SERIAL: BSEP 94-0356
10 CFR 50.90
TSC 94TSB10

BRUNSWICK NUCLEAR PLANT, UNIT NOS. 1 AND 2
DOCKET NOS. 50-325 & 50-324/LICENSE NOS. DPR-71 & DPR-62
REQUEST FOR LICENSE AMENDMENT
DRYWELL-SUPPRESSION CHAMBER VACUUM BREAKERS

BASIS FOR CHANGE REQUEST

Vacuum Breaker Cutaway

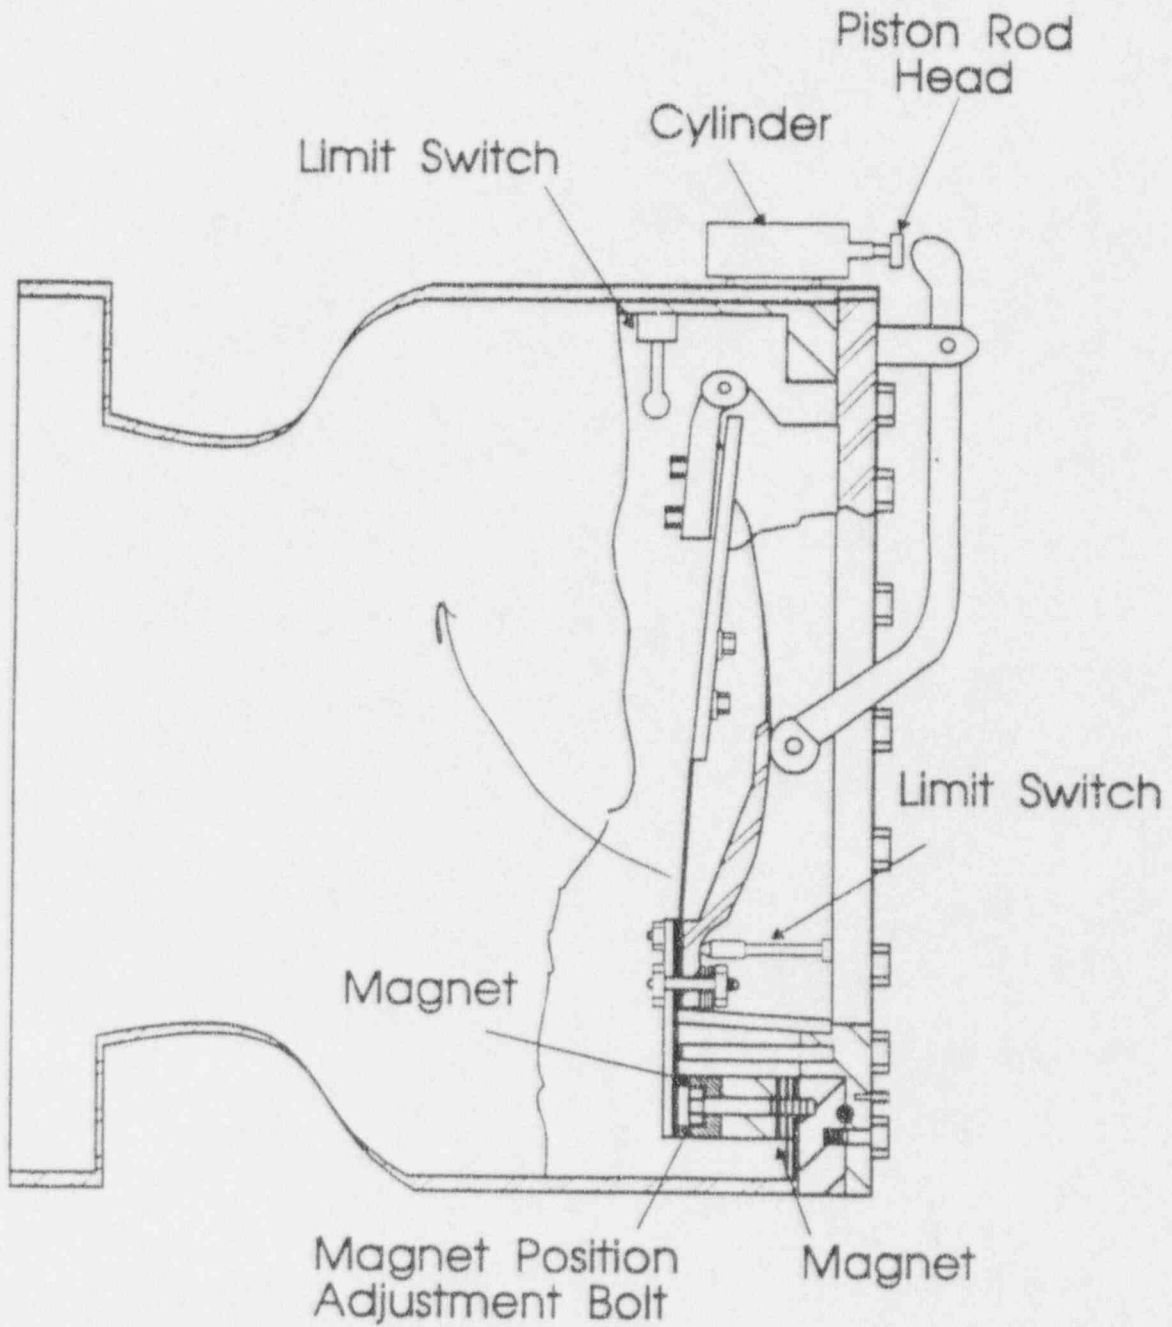
The Brunswick Plant design has ten (10) vacuum relief breakers to equalize pressure between the drywell and the suppression chamber. This system is intended to maintain the structural integrity of the primary containment under conditions of large differential pressures by bleeding non-condensable gases from the suppression chamber into the drywell. The valves automatically open any time the vacuum setting is exceeded; no failure of the position switches will prevent the valves from operating.

The vacuum breaker valves are furnished with pneumatic operators and limit switches to allow remote cycling with positive indication of valve pallet displacement. Failure of the vacuum breaker valves in a partially open position is unlikely since the valves are provided with magnetic latches to assure positive closing.

A sketch depicting the internal configuration of the vacuum breaker is enclosed.
